MISSISSIPPI DEPARTMENT OF TRANSPORTATION

SUBJECT OR PROJECT NO: BR-0016-01(034)/ 106912301000

The purpose of this addendum is to make the following changes:

Bridge Replacement on SR 8 over the Quiver River (Bridge No. 31.2), known as Federal Aid Project No. BR-0016-01(034) / 106912301 in Sunflower County.

| WORKING NUMBER | TS-1 |

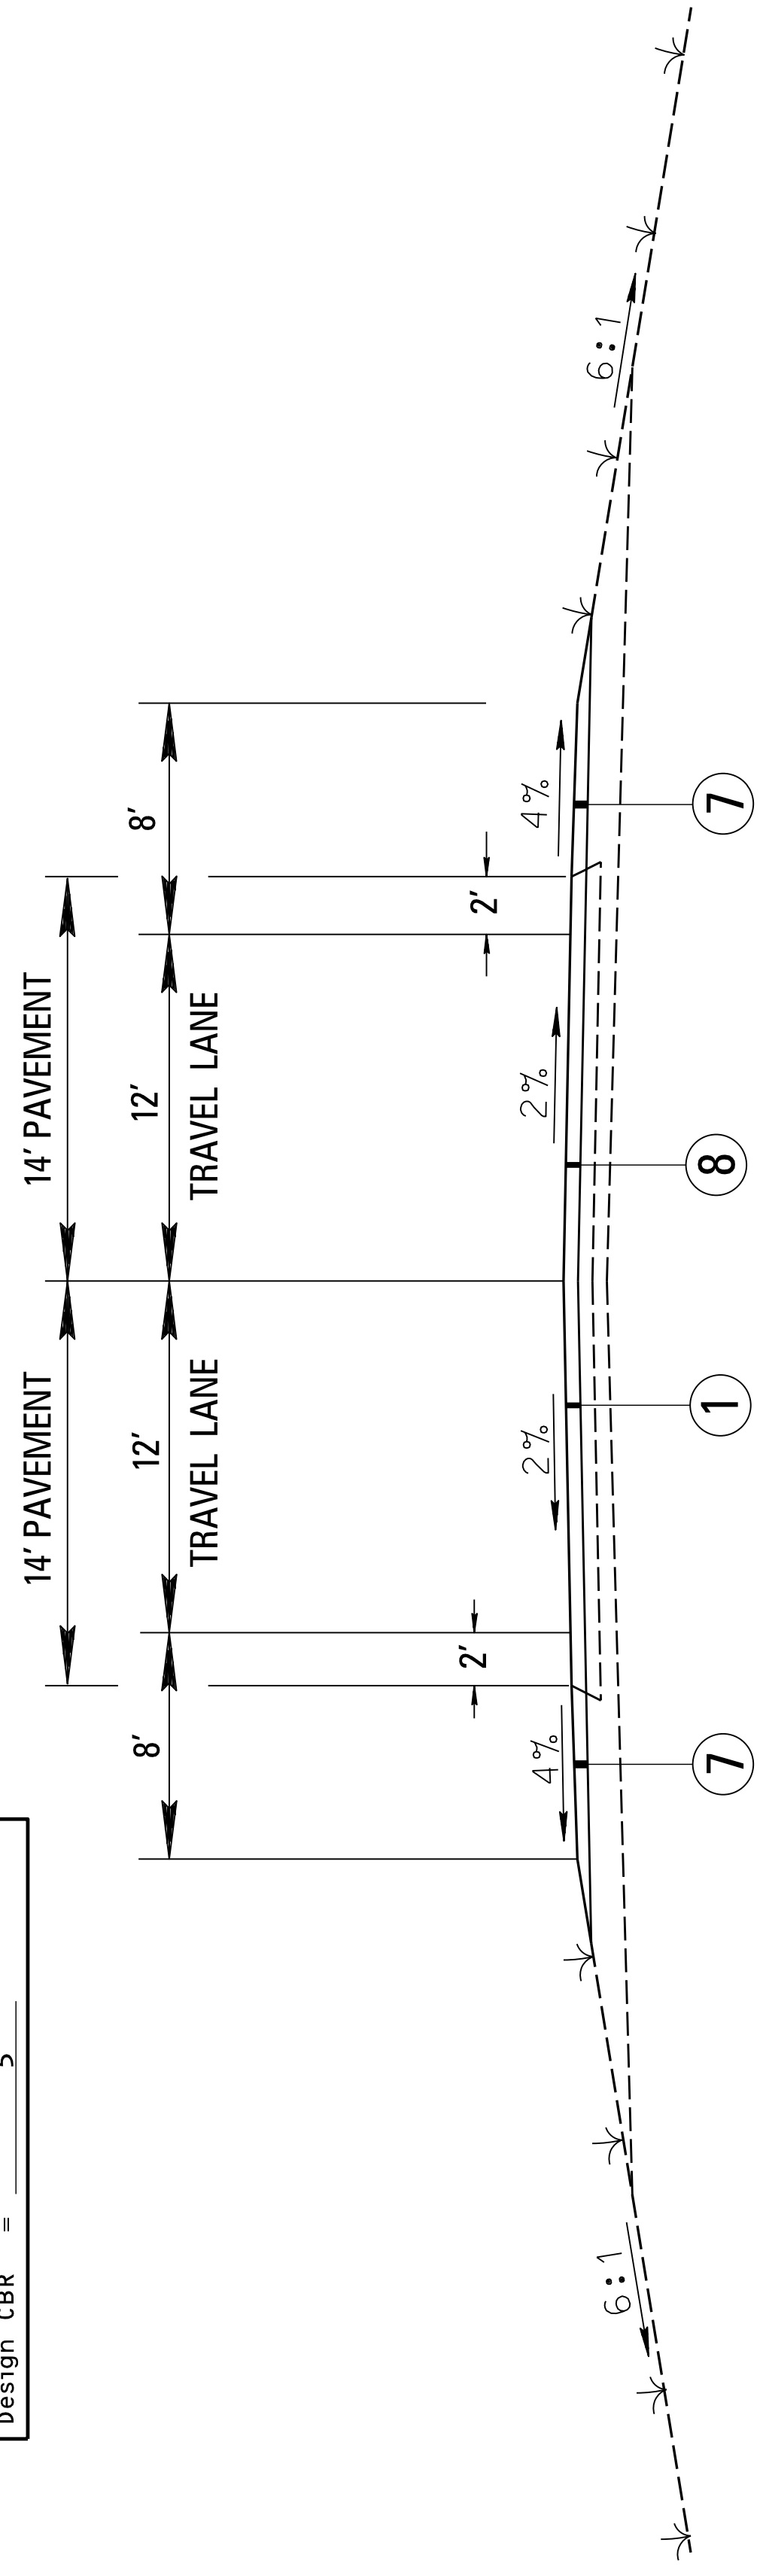
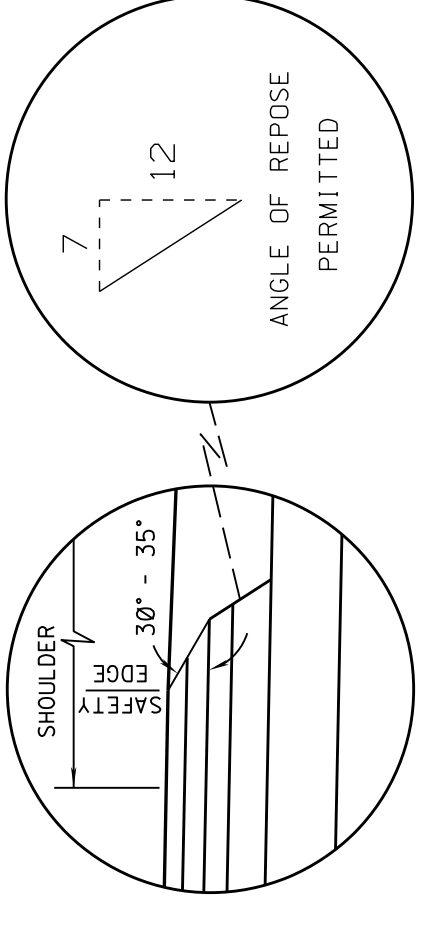
| REVISION | REVISED TYPICAL |

| COUNTY: SUNFLOWER | TS-2 |

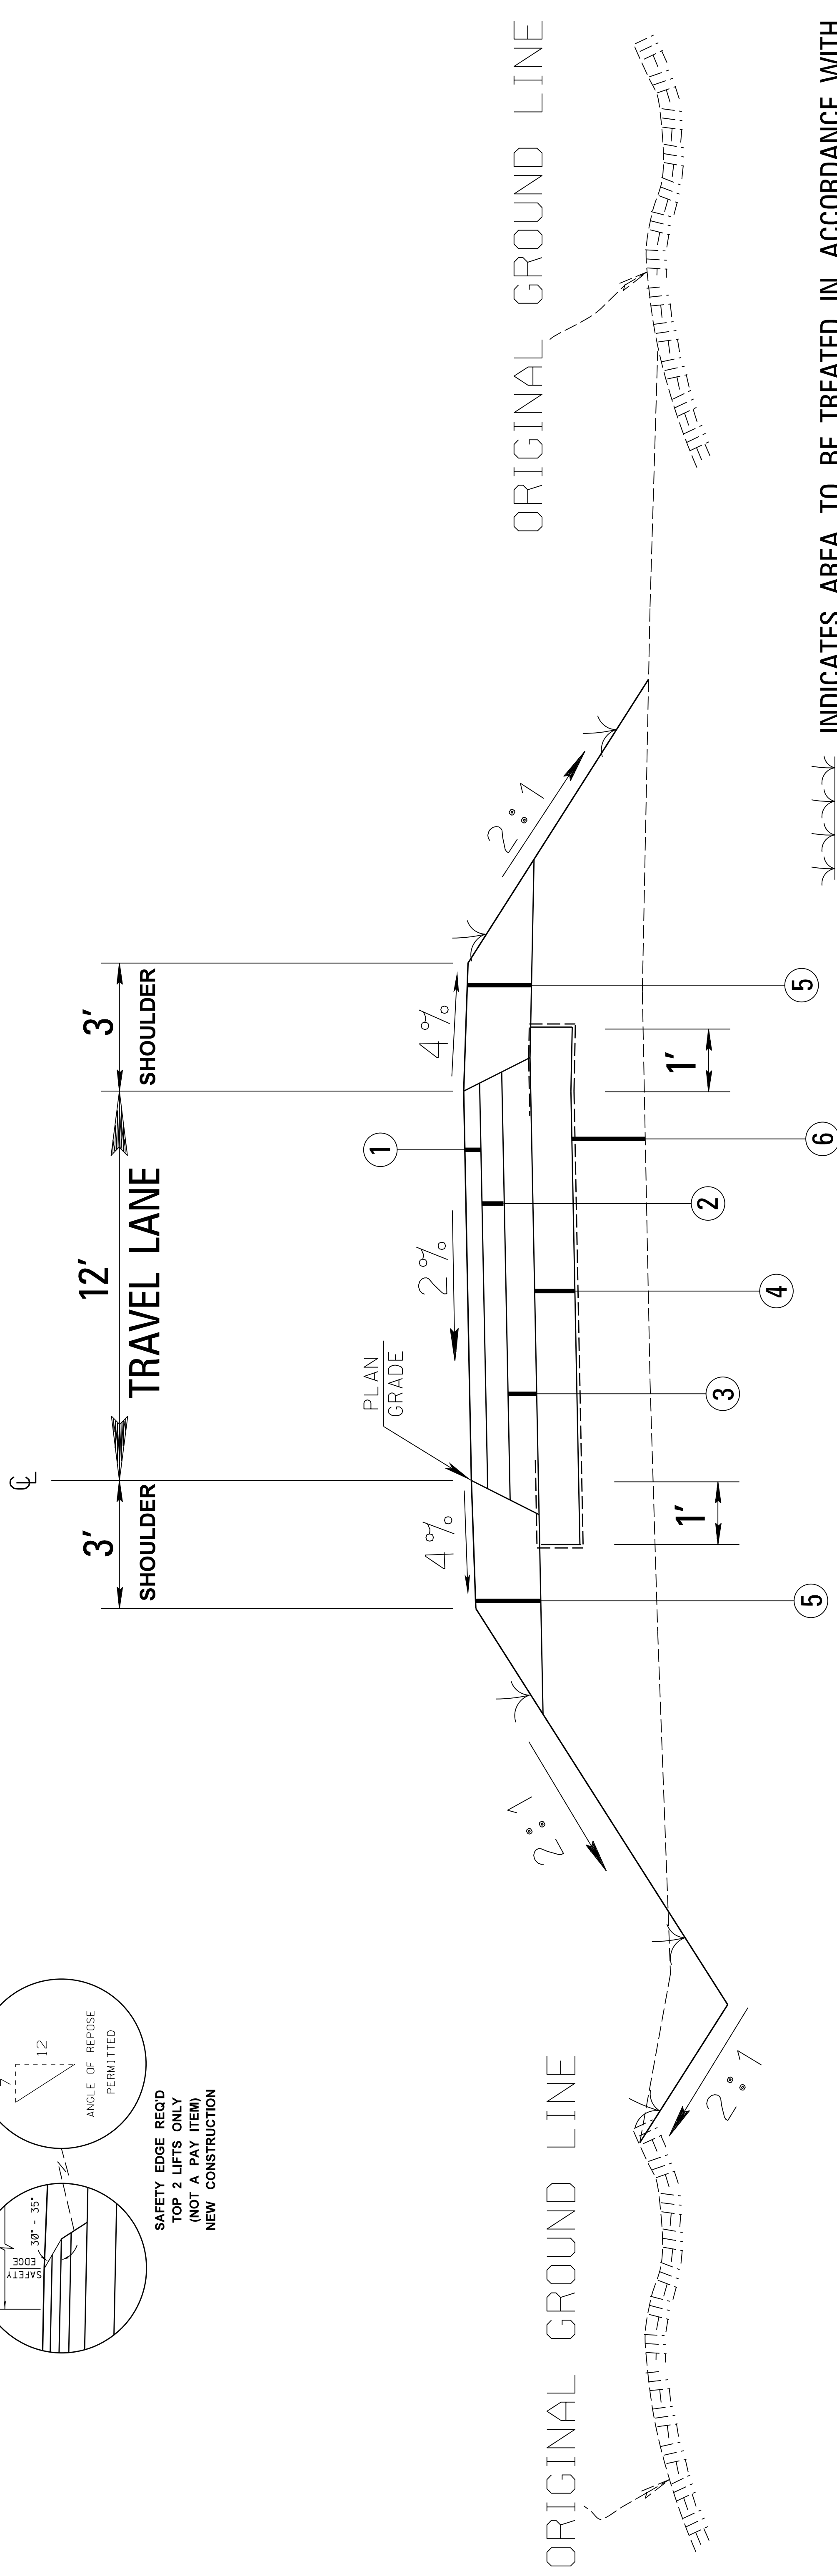
| REVISION TYPICAL | REVISION TYPICAL |

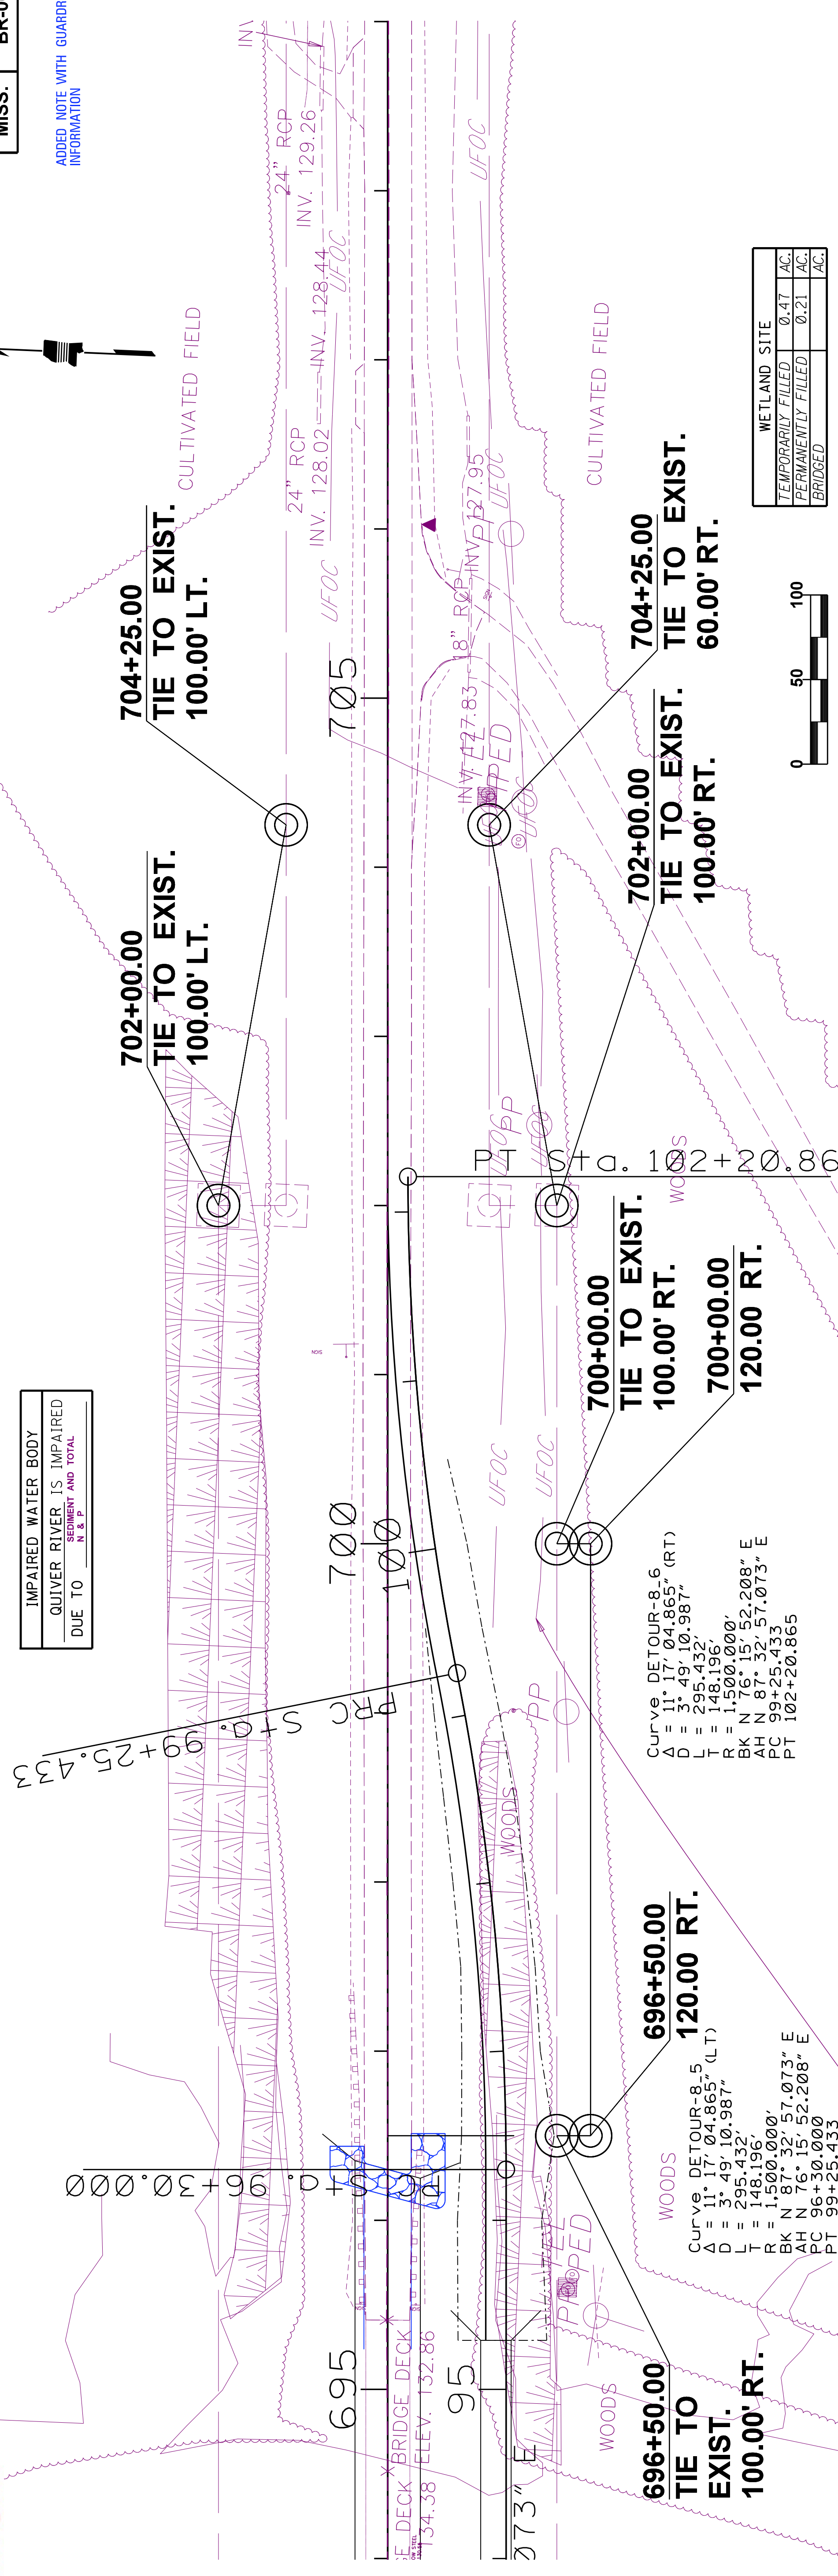
STA: 92+19
50.00' GUARDRAIL REQ'D. (TEMPORARY)
(25.00' LT., 25.00' RT.)
2 - TEMP. TERMINAL END SECTIONS REQ'D.
A = 0', B = 25.00' EACH

ADDED NOTE WITH GUARDRAIL INFORMATION

| TTS-1 | |

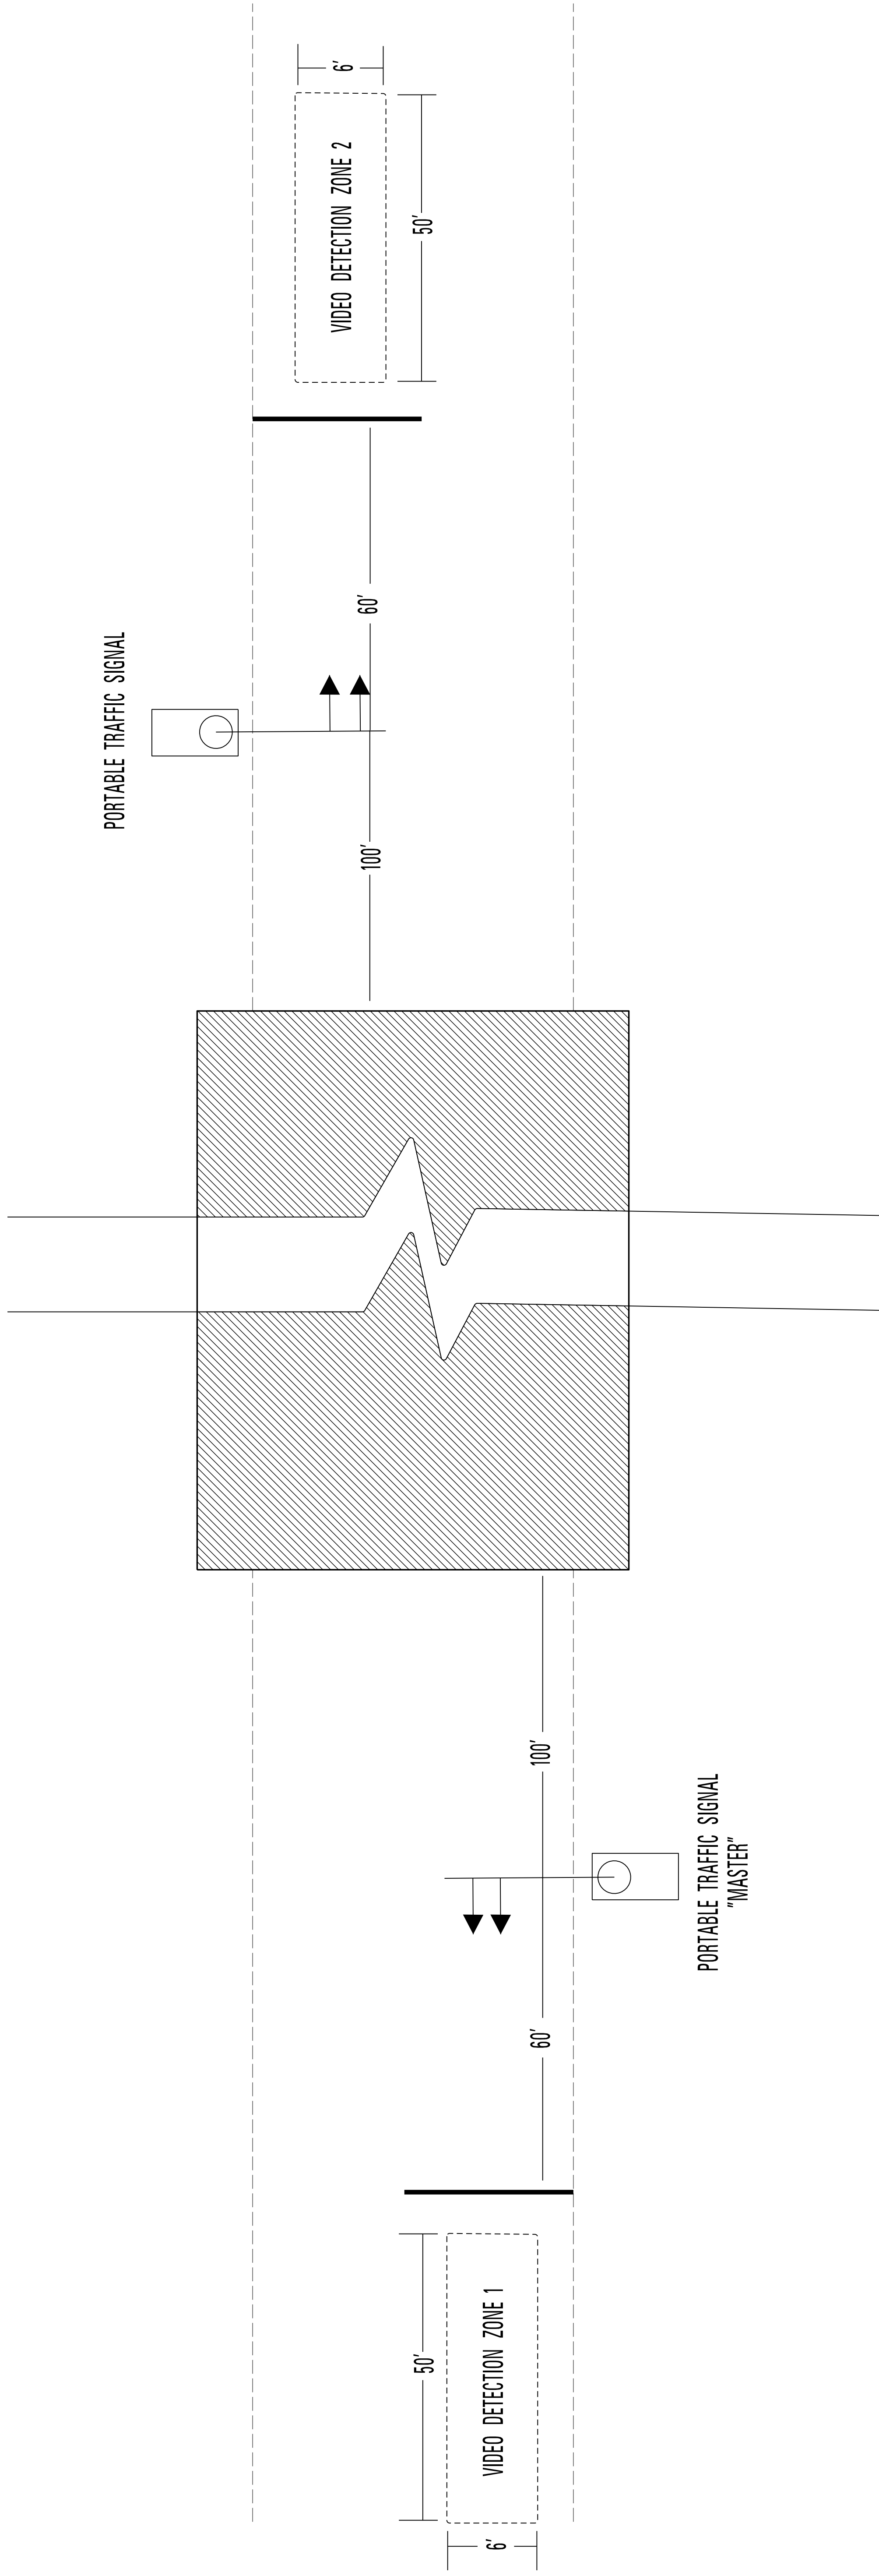
| 7/18/24 | REVISD PROJECT NO. AND COUNTY |
